# Access Compliance Report

## Public Rights-of-Way

### (Curb Ramps)

Intersection ID: 4659	Main Street: ASTORIA_DR	Cross Street: HARRIS_HOUSTON_RD	Location: W
ADA ID: A921BCE75ACD	Ramp Type: Perp	Initial Pass/Fail: Fail	Overall Compliance: No
Severity Score: 50			
Codes/Mitigation Info/Possible Solution		Field Measurements/Component Compliance

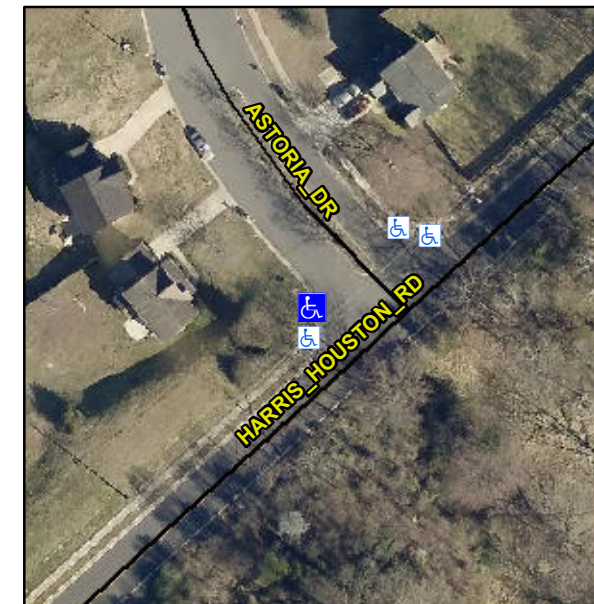
**R304.2.2, R304.5.3**

Compliance	Description	Data	Compliance	Description	Data
N/A	Ramp Length (in)	96.0	No	Ramp Slope (%)	16.0
Yes	Ramp Width (in)	48.0	No	Ramp XSlope (%)	15.0
N/A	Flare Type LT	N/A	N/A	Flare Type RT	N/A
N/A	Flare Slope LT (%)	N/A	N/A	Flare Slope RT (%)	N/A
N/A	Flare Traversable LT?	N/A	N/A	Flare Traversable RT?	N/A
N/A	Landing Length (in)	N/A	N/A	DWS Provided?	N/A
N/A	Landing Width (in)	N/A	N/A	DWS Contrast?	N/A
N/A	Landing Slope (%)	N/A	N/A	DWS Length (in)	N/A
N/A	Landing X Slope (%)	N/A	N/A	DWS Full Width?	N/A
N/A	Landing Curb? (Y/N)	N/A	N/A	DWS Offset (in)	N/A
N/A	Shared Landing?	N/A			
N/A	Gutter Ponding?	N/A	N/A	Gutter Slope (%)	N/A
N/A	Gutter Lip Ht (in)	N/A	N/A	Gutter X Slope (%)	N/A
N/A	Painted X Walk1?	No	N/A	Painted X Walk2?	N/A
	X Walk 1 Direction	To NE		X Walk 2 Direction	N/A
N/A	X Walk 1 Width (in)	N/A	N/A	X Walk 2 Width (in)	N/A
	X Walk 1 Slope (%)	4.9		X Walk 2 Slope (%)	N/A
	X Walk 1 X Slope (%)	11.9		X Walk 2 X Slope (%)	N/A

**Remove & Replace Entire Ramp.**
